City of Greenville, Ohio
WWTP Solids Handling Facility and Administration Building

ADDENDUM 3

1.16.2025

EXISTING STORM BASIN BLOWER BUILDING - INTERIOR

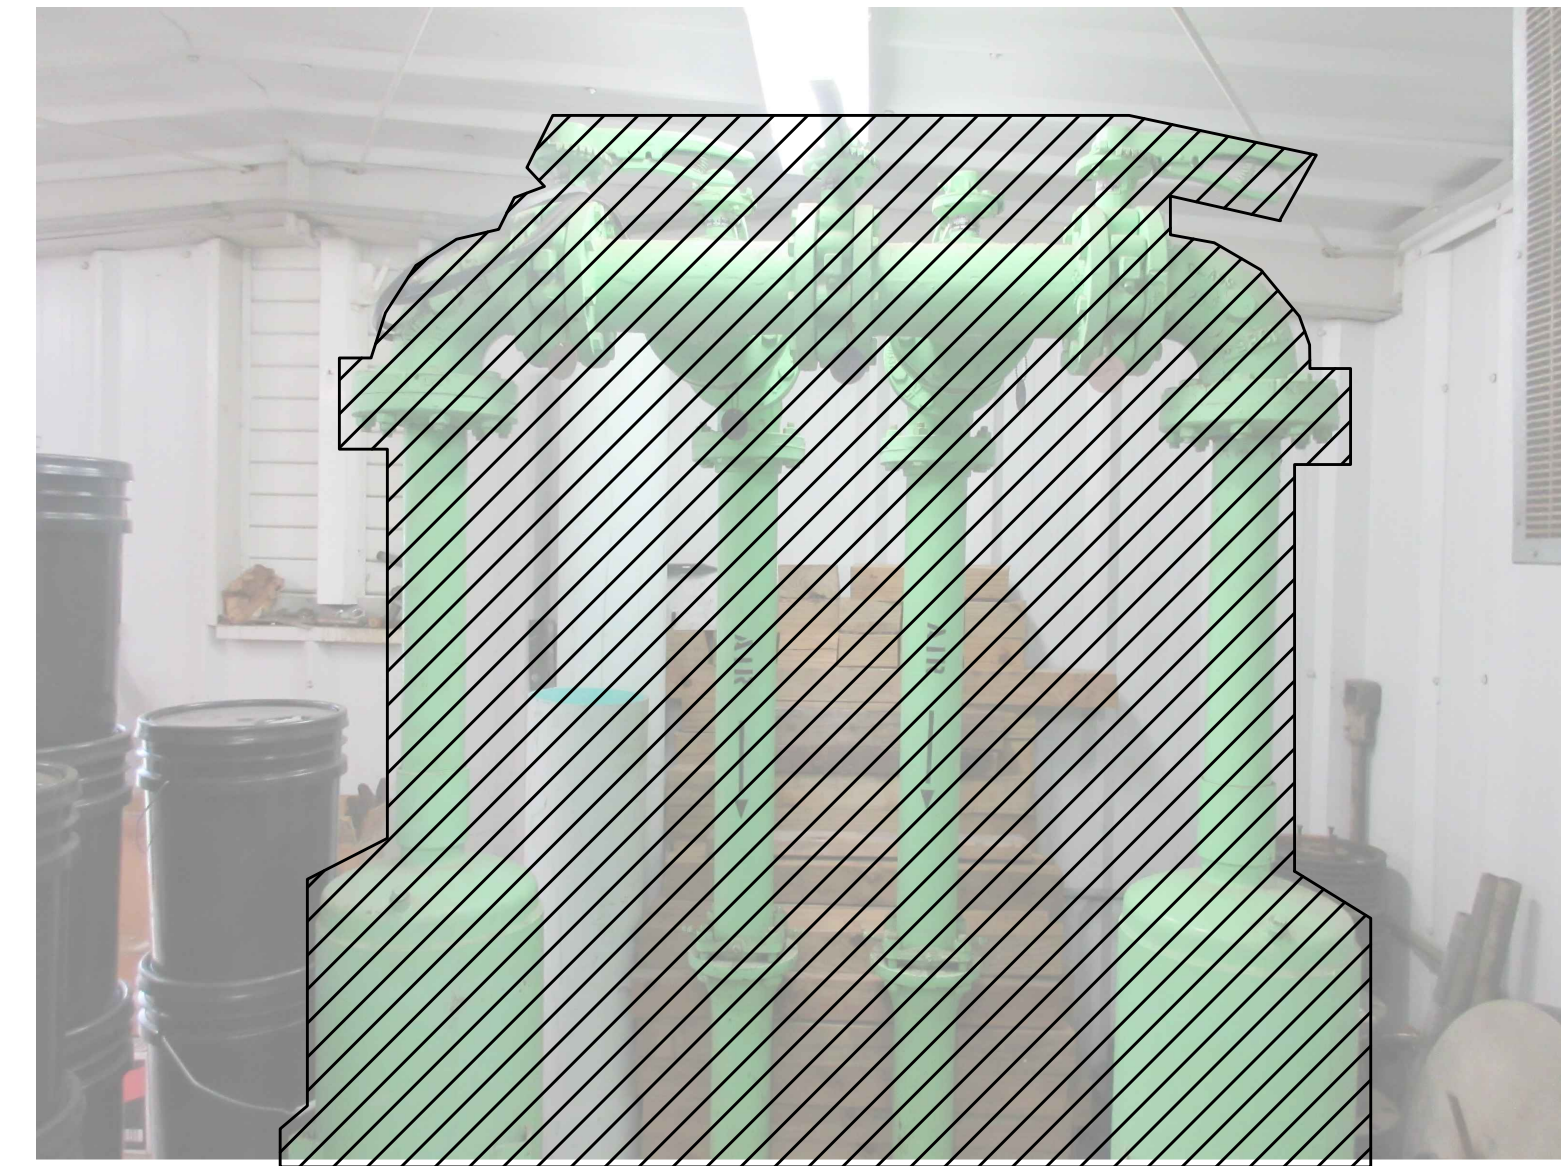
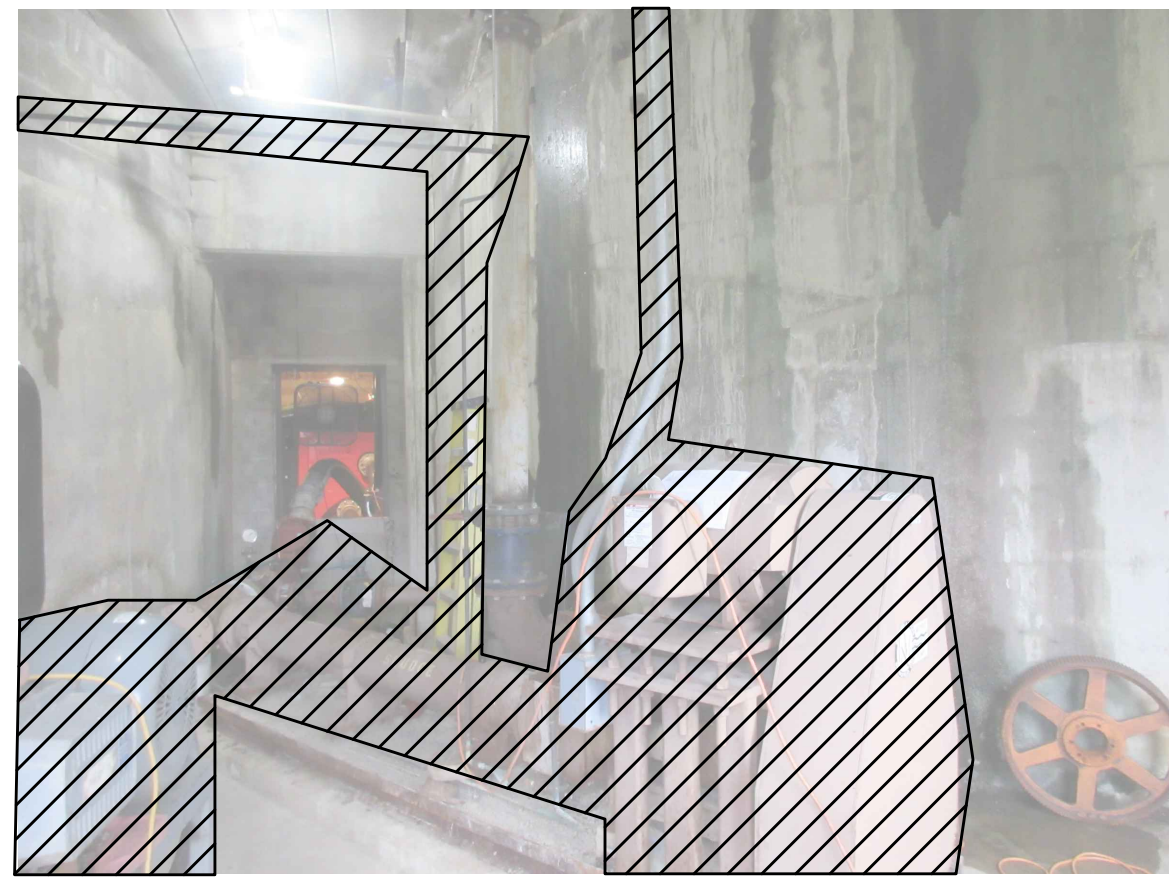
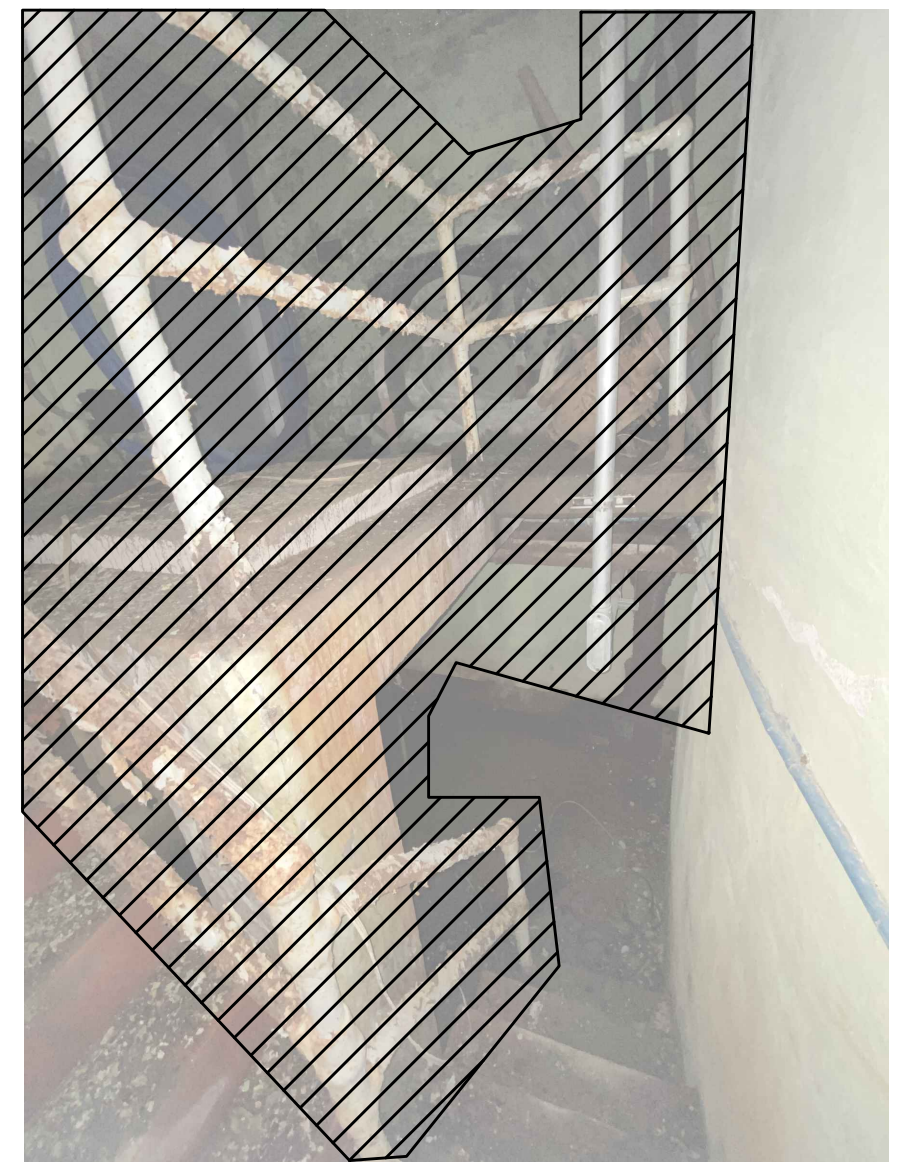
Question: Sheet R-0.2 shows an existing Blower Bldg being demolished. Are drawings available that show this structure? What are the extents of the demolition and backfill requirements?

Response: *Drawings are not available for this structure. We have included a Removals sheet with photos of items that need removed.. Refer to R0.2 and R0.8 sheets included in Addendum 3.*

- NOTES:**
1. DEMOLITION WORK ON STORM BASIN BLOWER BUILDING TO START ONLY AFTER COMPLETION OF ELECTRICAL SYSTEM INSTALLATION AND ELECTRICAL/BLOWER PIPING TIE-INS TO STORM BASIN DIFFUSERS AND MIXERS.
 2. ONCE ALL THE TIE-INS ARE DONE, THEN THE CONTRACTOR SHALL REMOVE ALL PIPING, EQUIPMENT AND APPURTENANCES INSIDE STORM BASIN BLOWER BUILDING.
 3. UPON COMPLETION OF EQUIPMENT AND PIPING REMOVAL, STORM BLOWER BUILDING SHALL BE DEMOLISHED.
 4. AS PART OF PROJECT SUBSTANTIAL COMPLETION, TEST OPERATION OF STORM BASIN AND ENSURE MIXERS AND DIFFUSERS ARE OPERATING SUCCESSFULLY.

EXISTING SLUDGE HOLDING TANK - SOUTHEAST

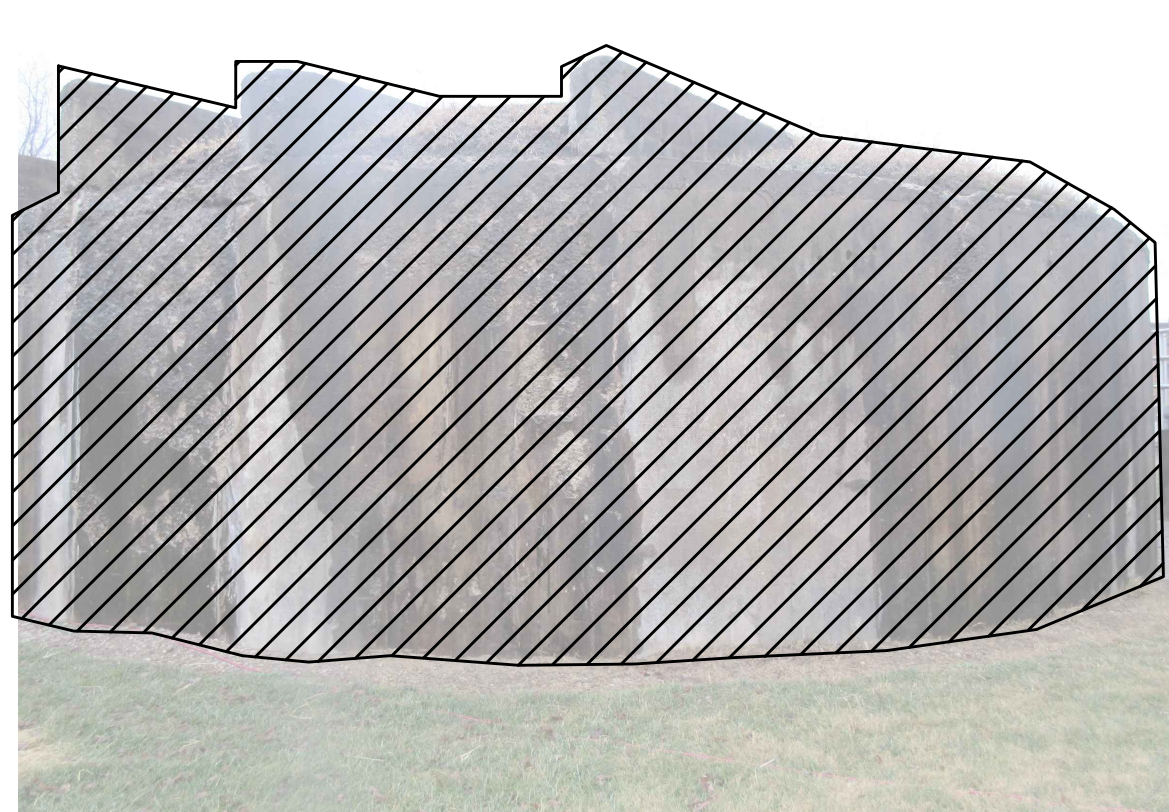
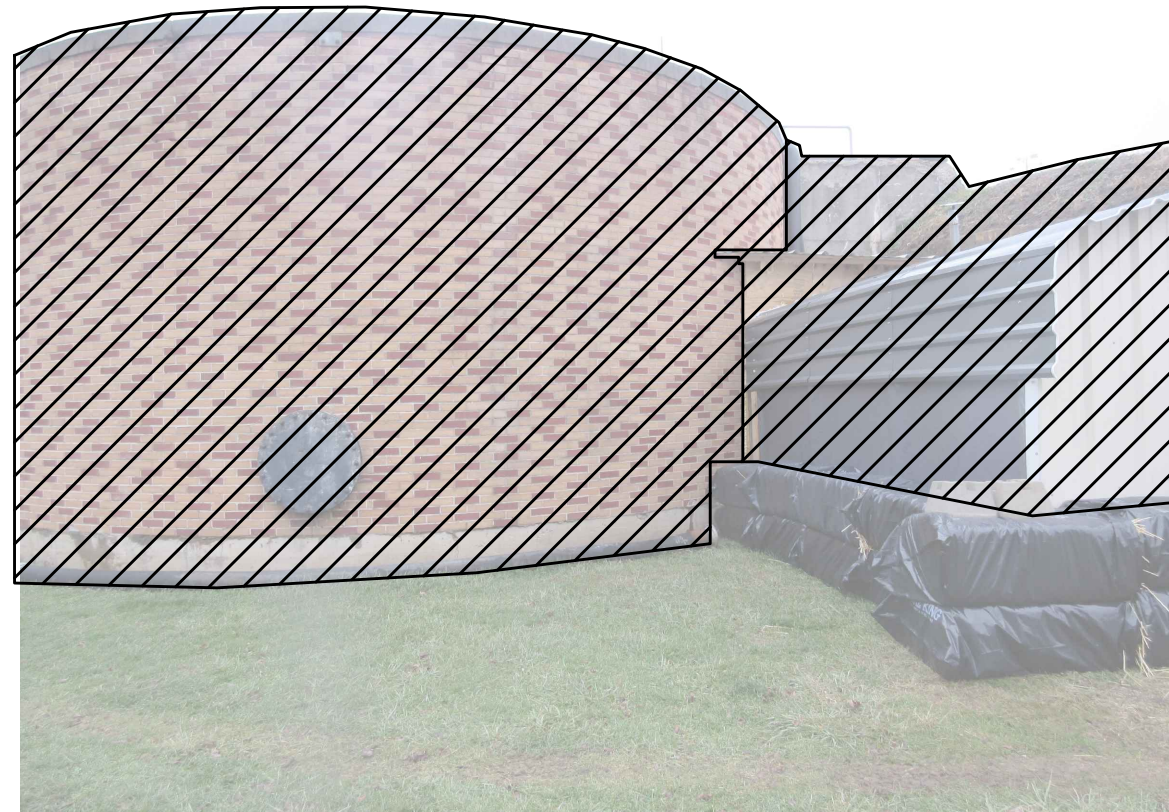
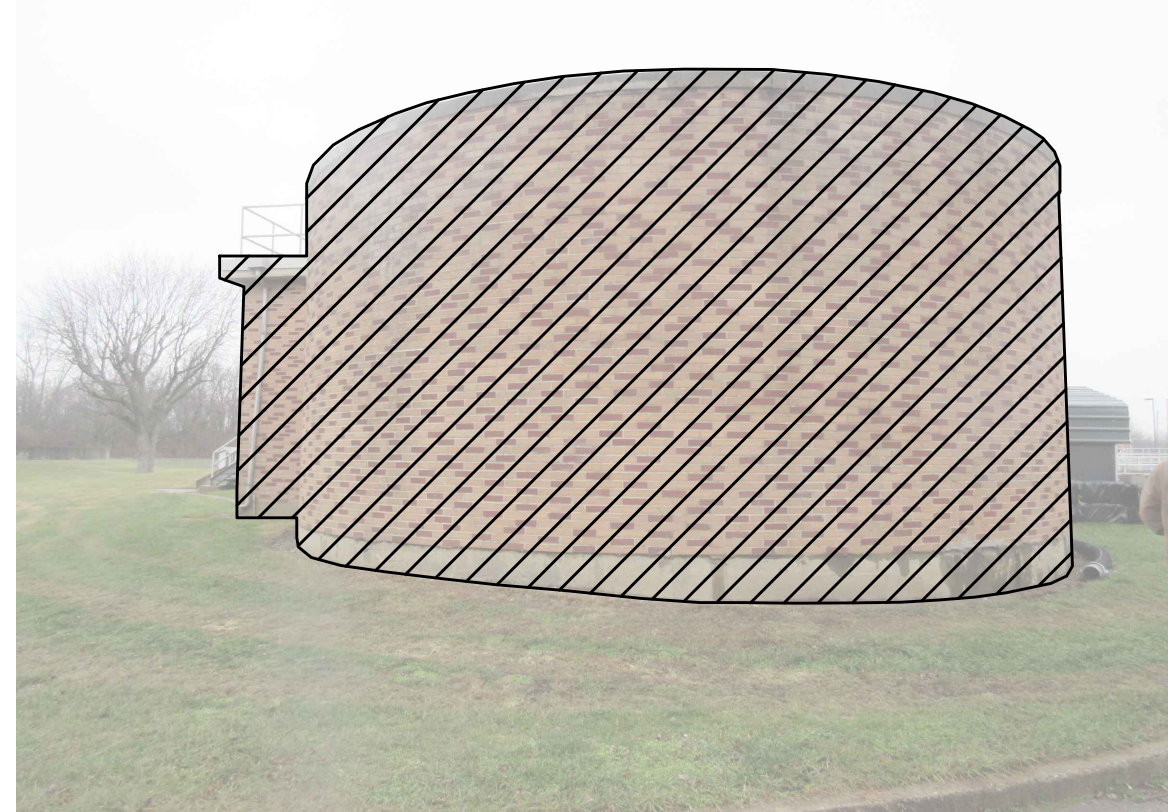
Question: Sheet R-0.3 shows an existing Sludge Holding Tank and Sludge Digester tank being demolished. Are drawings available that show these structures? What are the extents of the demolition and backfill requirements? Is there any sludge to remove? If so, who is responsible?

Response: *Drawings are not available for this structure. We have included a Removals sheet with photos and notes to scope the removal work Refer to R0.7 and R0.9 sheets included in Addendum 3.*

- UPON COMPLETION AND OPERATION OF NEW SYSTEMS, REMOVE STRUCTURES TO 4' BELOW FINISHED GRADE. CORE HOLES IN BOTTOM SLABS. REMOVE ALL PIPING, EQUIPMENT AND APPURTENANCES WITHIN STRUCTURES.
- EXISTING SLUDGE HANDLING TANKS AND ASSOCIATED EQUIPMENT SHALL BE ABANDONED ONLY AFTER THE SOLIDS HANDLING SYSTEM AND DIGESTERS ARE FULLY OPERATIONAL. CONTRACTOR TO COORDINATE WITH OWNER PRIOR TO ABANDONMENT OF EXISTING SLUDGE HANDLING FACILITY SYSTEM DEMOLITION.

ROLLING GATE DETAIL

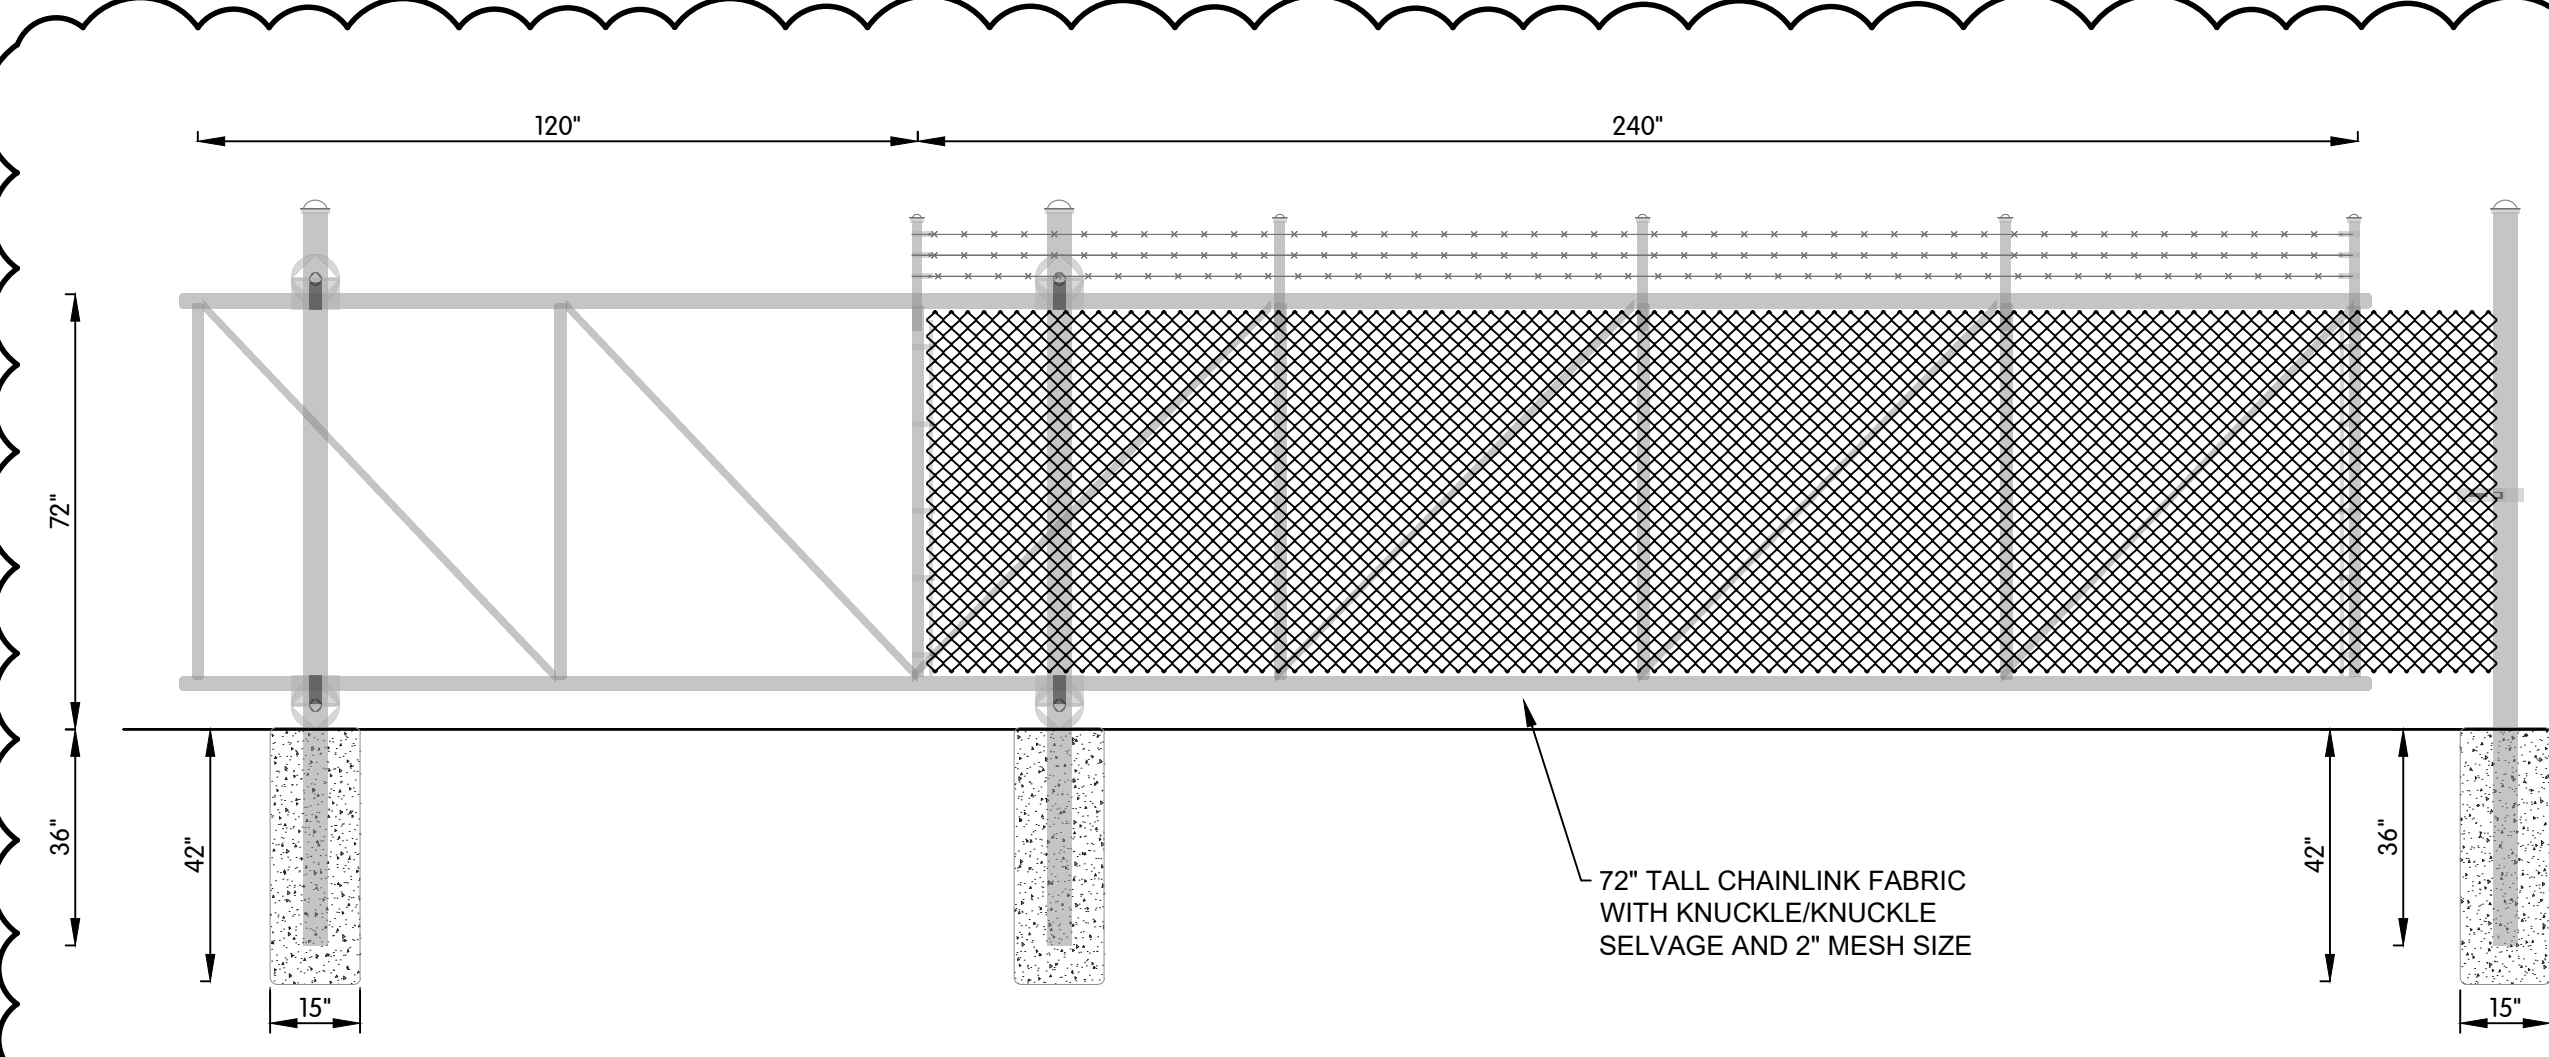
Question: Roll gate drawn in sheet C-0.4 shows what we call a California or Florida roll gate- They are called that because they don't work in Ohio with snow and ice. Shouldn't this be a cantilever roll gate? They also show the gate rolling into a man gate- with an operator; this isn't even legal to do with UL 325 code. Should this be put right off the corner at least a foot from the gate?

Response: *Gate shall be Cantilever roll gate, 6 feet tall and 30 feet wide (20 feet opening) with 1- feet barbed wire in top. Gate shall be galvanized steel and rust resistant. Refer to updated C0.4 Sheet included in Addendum 3.*
